Waterford Unit 3 GSI-191 Generic Letter 2004-02
Corrective Actions Audit Report

ENCLOSURE

Figure 1: Waterford 3 Containment Pool Flow Velocity for Break S7

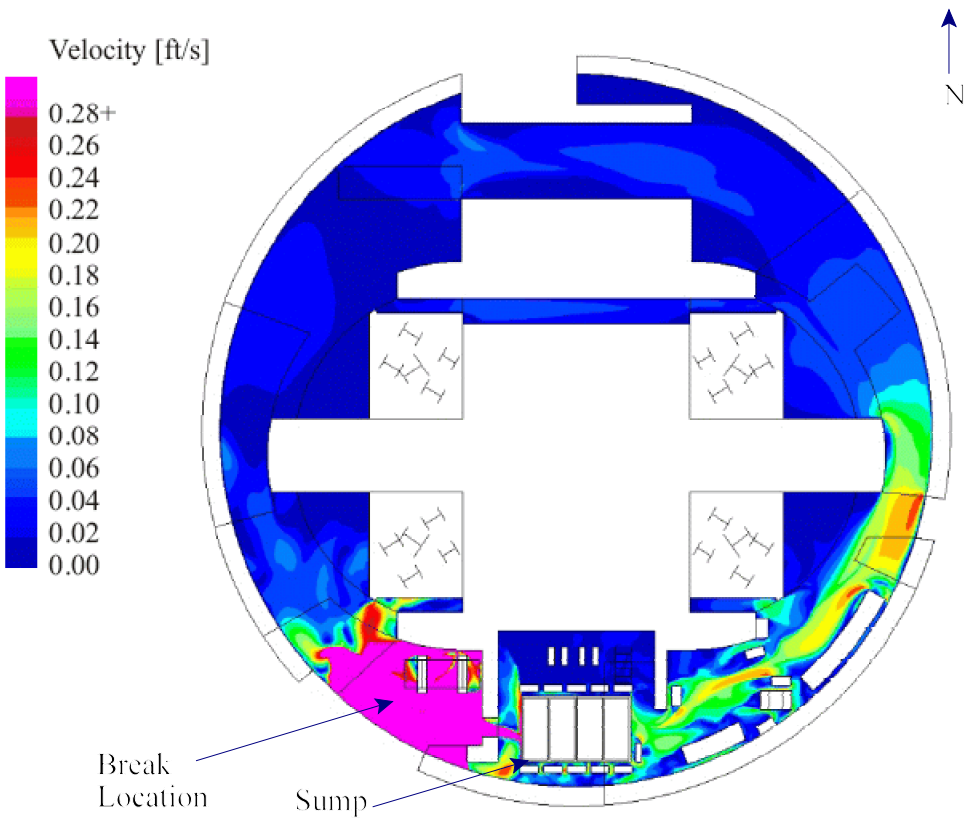
The first concern is that the staff concluded that there is inadequate technical basis for the licensee to assume that the percentage of debris transporting along the east and west sides of containment is equal to the percentage of flow approaching the sump from the east and west side of containment. Although there are limited conditions under which the licensee's assumption may be reasonable, the staff expects that the location of the break would generally have a significant impact on which side of containment debris will transport, regardless of the flow split between the east and west sides of containment. The staff's expectation is borne out by most of the plots of pathlines from the breaks to the containment sump that are included in the debris transport calculation for the CFD simulations performed by the licensee [16]. These plots suggest that debris transport would be generally biased toward the side of containment on which the break occurred and, in many cases, overwhelmingly so. Furthermore, as noted in the

debris transport calculation, the flow in the Waterford Unit 3 containment pool was found to be highly three-dimensional [16]. This observation further suggests that the use of the total flow to the sump from the east and west sides of containment (i.e., a summation over the vertical flow distribution across the entire 5.05-foot depth of the containment pool) may not be a reasonable predictor of the direction of travel for pieces of Nukon and RMI debris transporting predominately only several inches above the containment floor. The lack of technical validity of the licensee's assumption is significant because the use of the assumption could result in non-conservatively low debris transport fractions under some conditions if sufficient countervailing conservatisms are not incorporated into the analysis.

The second concern is that the licensee's debris transport calculation did not clearly define the point at which the transport paths from the east and west sides of containment to the sump strainers were assumed to begin. Although the results of the licensee's transport calculation were consistent with the interpretation that the transport path on the side of containment with the pipe rupture begins at the point where this break water enters the containment pool, the licensee could not explain where the transport path on the opposite side of containment was assumed to begin.

For a related case in point, consider Figure 1 above. Clearly, as the licensee determined, the transport metric for Nukon LDFG for the S7 Break (0.06 ft/s) is exceeded on the west side of containment. However, the licensee further determined that no transport from the east side of containment would occur for this break. While it is clear that the flow velocities in the clockwise direction from the break to the sump in the annulus around the steam generator compartments is too low to transport all but suspended debris, there is a flow stream in the southeast quadrant that appears to be significantly in excess of both the assumed tumbling transport metric of 0.06 ft/s for near-sump Break S7, as well as the assumed transport metric of 0.12 ft/s for breaks far from the sump (see Table 5 above). Analogous observations were made concerning the other breaks analyzed by the licensee. As a result of these observations, the staff questioned the licensee's basis for assuming that no debris would be transported to the sump via flow streams such as those identified in Figure 1 above. In particular, the staff noted that debris could be situated in relatively high velocity flow streams on the side of containment opposite the break due to transport occurring during the blowdown, washdown, and pool-fill-up phases of the LOCA. The licensee did not provide a sufficient basis during the audit to resolve the staff's questions in this area.

Figure 2 - Sector Head Loss Test Loop

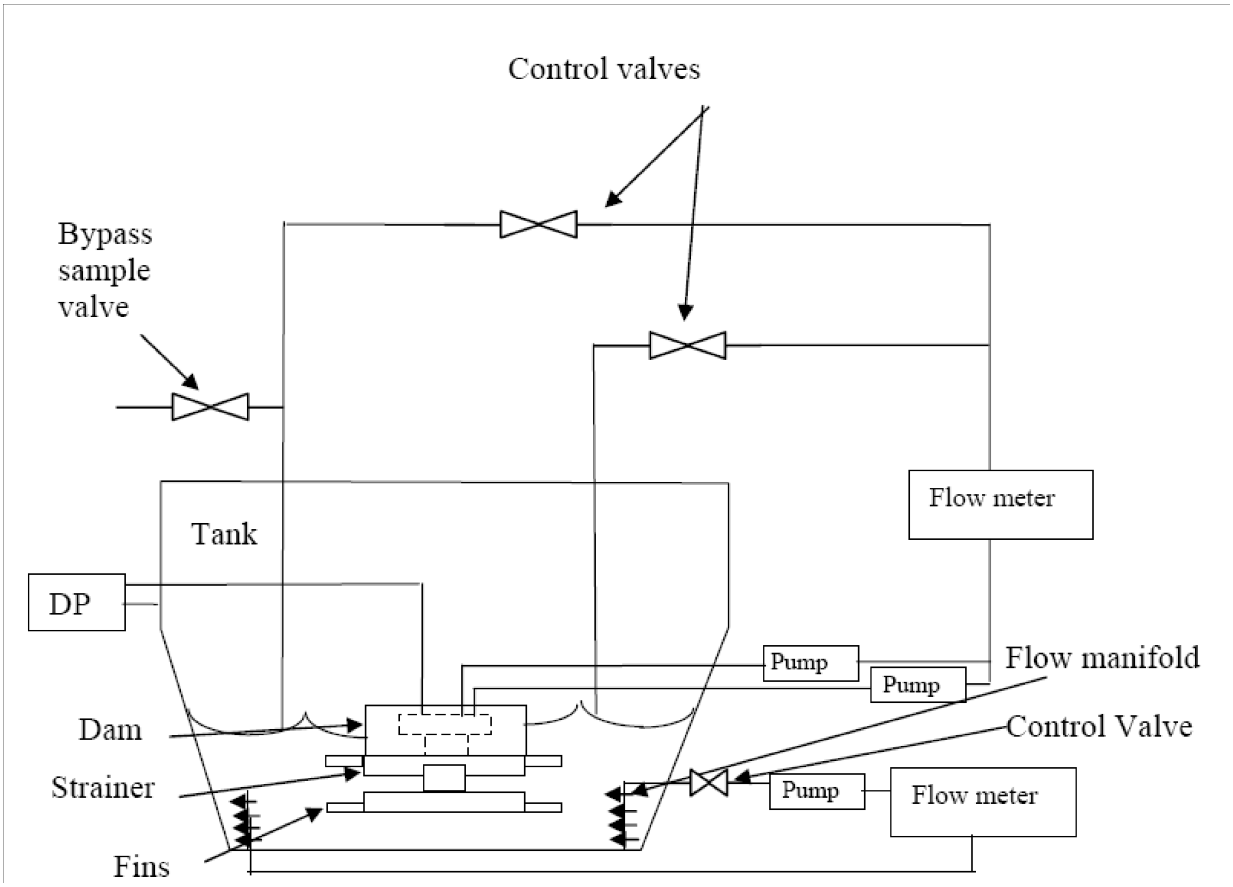
The addition of the fibrous debris in a mass close to the test strainer results in two non-prototypical effects as described above. The need for the licensee to provide the results of assessment of the potential for non-prototypical settling and non-prototypical bed formation due to debris agglomeration during partially stirred strainer testing is designated as **Open Item 10.**

Figure 3 - Waterford 3 Strainer Array

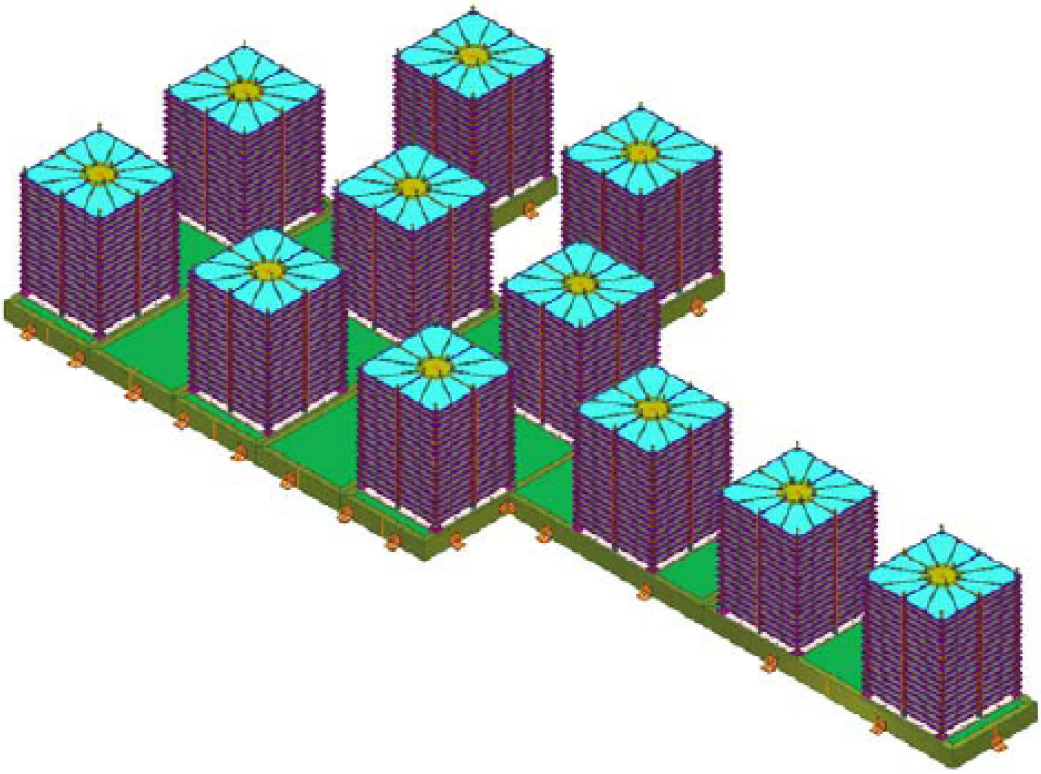
Because an industry standard flow resistance calculation evaluation for pipes and ducts was used to calculate the strainer internal head losses, the methodology is considered acceptable. Appropriate conservatism was added to the analysis for consideration of instrument uncertainty. The application of the maximum plenum head loss to all strainer modules is certainly conservative. Based on the above, the staff found the clean strainer head loss determination to be acceptable.
